Linda Lacelle **Process Sheet Drawing Name** : PAD : CU-DAR001 Dart Helicopters Services : 27325 **Estimate Number** : 11205 **Part Number** : D31957 :110 P.O. Number S.O. No. : 1/1A : 6/1/2006 : D3195 REV A **Drawing Number** : N/A Project Number : NA : SMALL /MED FAB Type **Drawing Revision** AIH: : 26337 Material **Previous Run** : 6/8/2006 Qty: 50 Um: Each **Due Date** Checked & Approved By New Issue 05-12-05 JLM : Est Rev:A **Additional Product** Description: **Machine Or Operation:** Neoprene 1/8" thick D3195 1.0 Comment: Qty.: 0.0197 sf(s)/Unit Total: 0.9870 sf(s)Make from D3195 Neoprene 1/8" thick Material:Neoprene 1/8" thick 06.06.0 Batch: SMALL & MEDIUM FAB RESOURCE 1 2.0 Comment: SMALL & MEDIUM FAB RESOURCE 1 Cut & Punch as per Dwg D3195 INSPECT WORK TO CURRENT STEP 3.0 QC5 Comment: INSPECT WORK TO CURRENT STEP PACKAGING RESOURCE #1 4.0 PACKAGING 1 Comment: PACKAGING RESOURCE #1 Identify and Stock Location: 5 DOCUMENT CONTROL 5.0 Comment: DOCUMENT CONTROL Inspection Level 21 CLOCE 08117 Job Completion

D3195-5 & D3195-7 PAD

RE: D3195 pad change

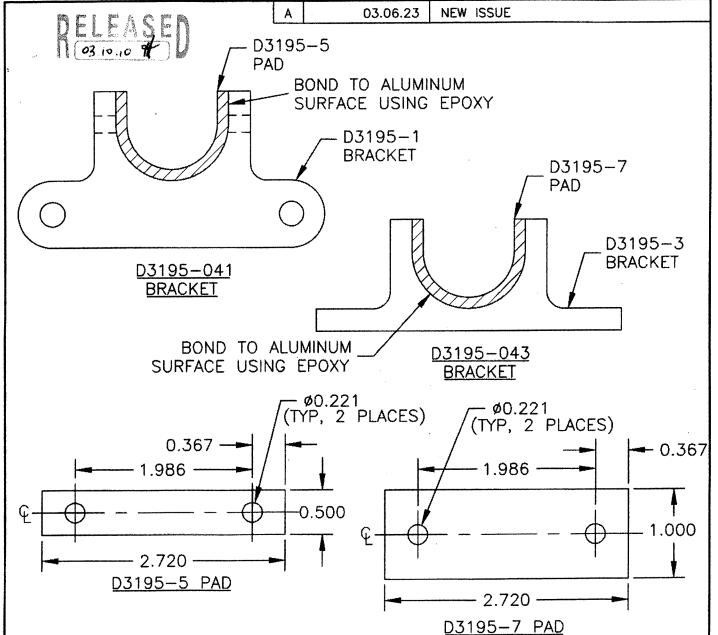
| | | | | WORK ORDER CHANGES | | | | | | | | |
|------|------------------|------------|--|--------------------|---------------------------------|---|--|--|--|--|--|--|
| | 2 | TO 73/55-7 | CUT D3195-7 PAD SO THAT IT IS FLIGH WITH EDGES OF D3195-3 BRACKET TRANSFER LKATION OF \$0.221 HOLES FROM D3195-3 TO 73195-7 (see D5 cmc, 1 attacky) | TO 3195-7 | T6 73/55-7 | 2 Cut D3195-7 PAD SO THAT IT IS FLISH WITH EDGES OF D3195-3 BRACKET TRANSFER LKATION OF \$0.221 HOLES FROM D3155-3 BLOW 60.06.6) PUT DO 33195-7 | | | | | | |

The D3195-5/-7 Pads should be 2.50" long instead of 2.720". Sylvie showed me the parts and I agree.

If made to drawing they are too long. In the past they've done them to fit the brackets (2.50" long and making the holes by transfering the location from the brackets).

For this batch they should have a signed-off change to the work order. I will instruct them to cut the length to be flush with the bracket and transfer the location of the hole from the D3195-1/-3 brackets. Is this change OK?

Obviously, this is an acceptable deviation.
